04-04-27^{-day} Savelle
proposer netu
sites

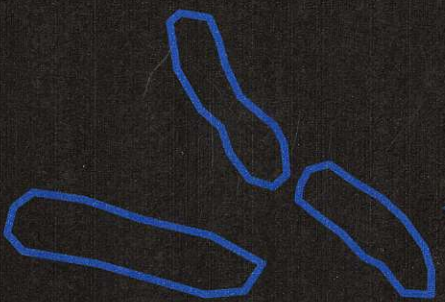
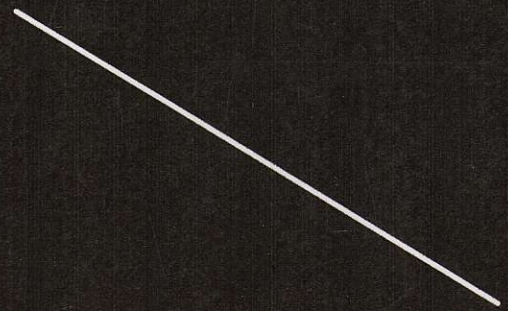
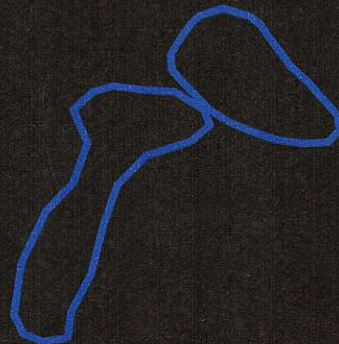
ALTERNATIVE
TUNNEL ROUTE??

ALTERNATIVE TAILINGS
DISPOSAL AREAS??

WATER COURSES IN RED HAVE SALMON PRESENT
ACCORDING TO BC FISHERIES / DFO

- can't see on original either

Section 1 - Side Dump on Bench

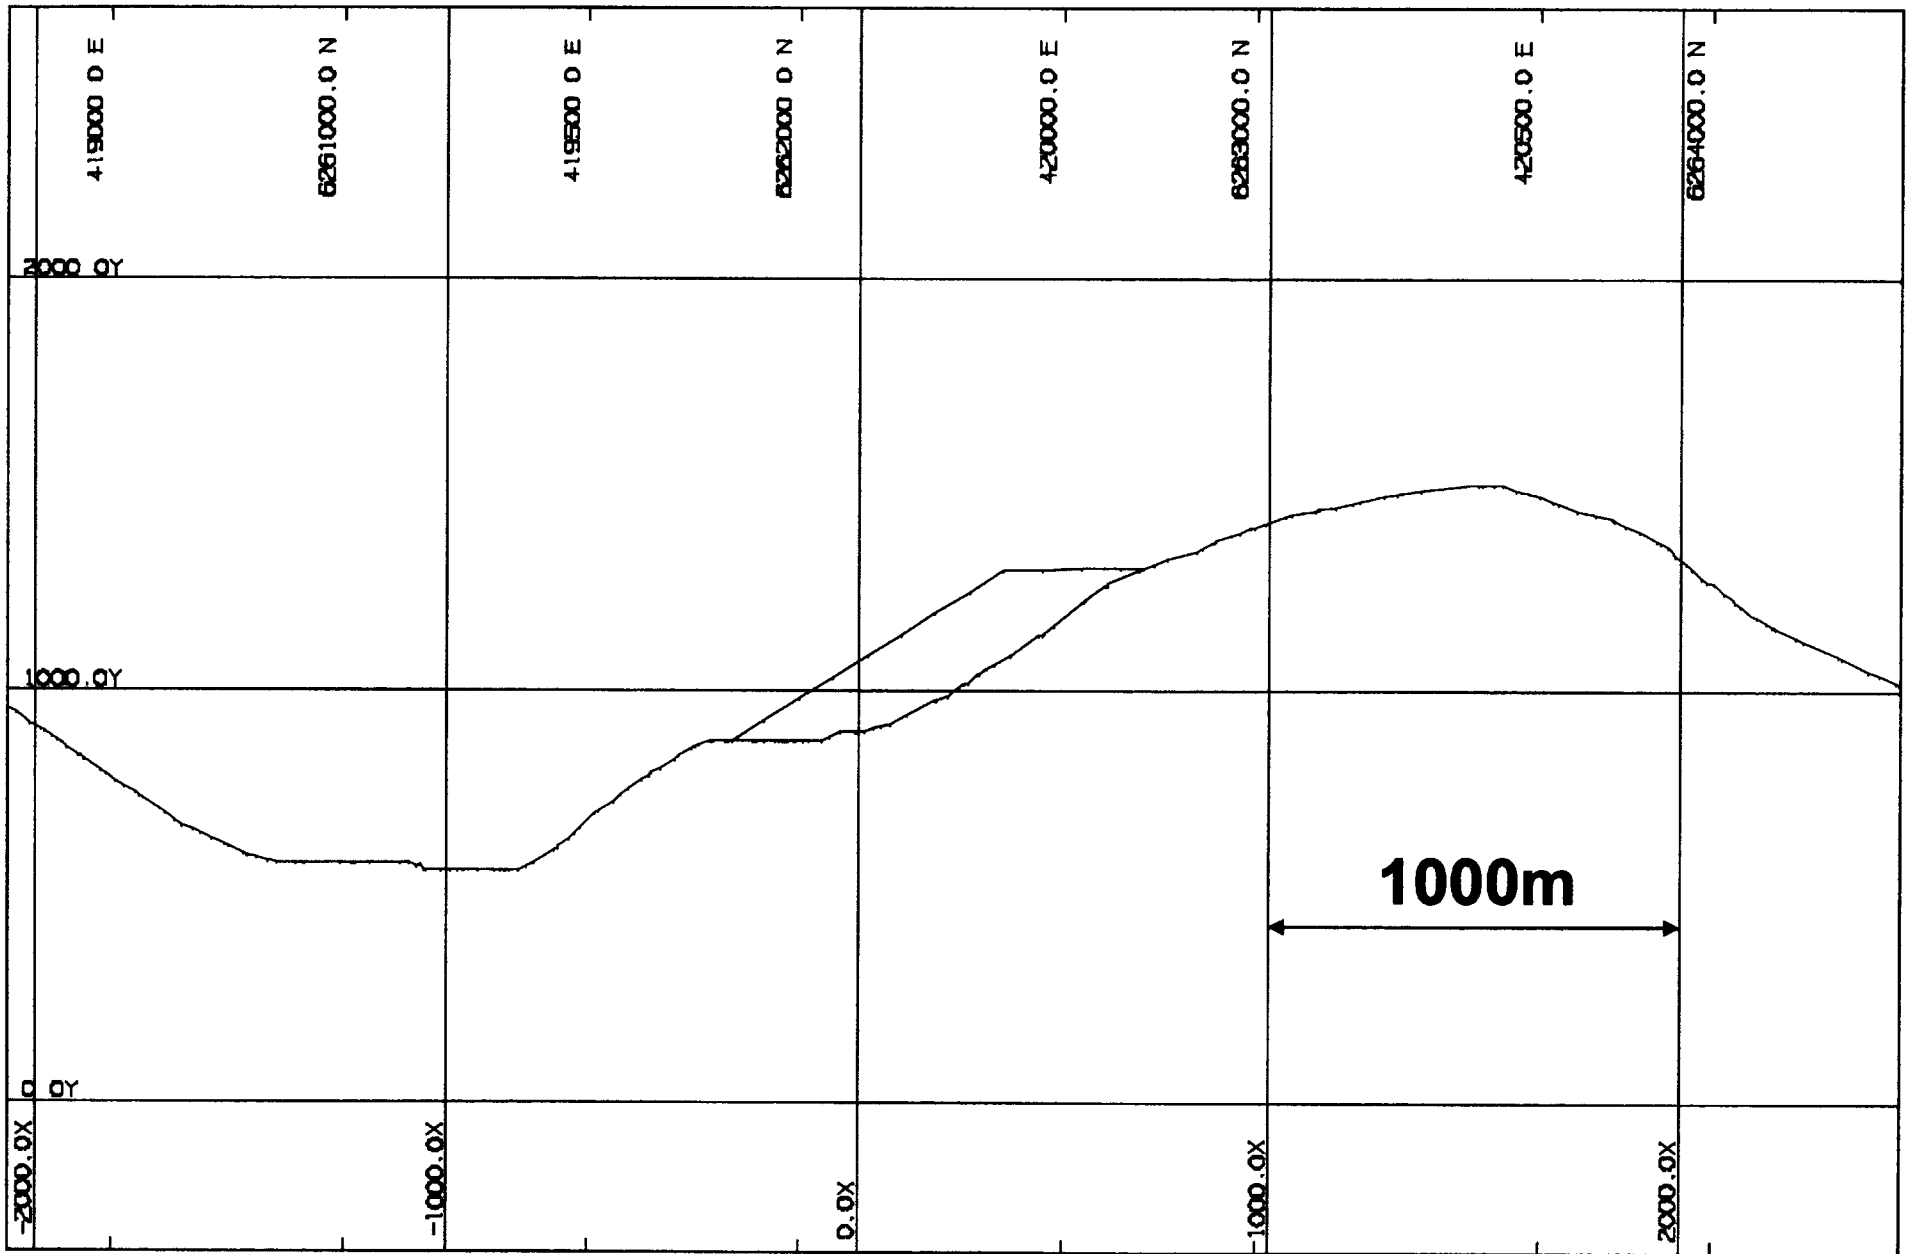
**SIDE DUMP ON BENCH CAPACITY:
+500 Mm³ - CAPTURE AND TREAT
DRAINAGES?**

**CURRENT PIT LAKE CAPACITY:
~20 Mm³ - could easily be tripled
with redesigned pit shell**
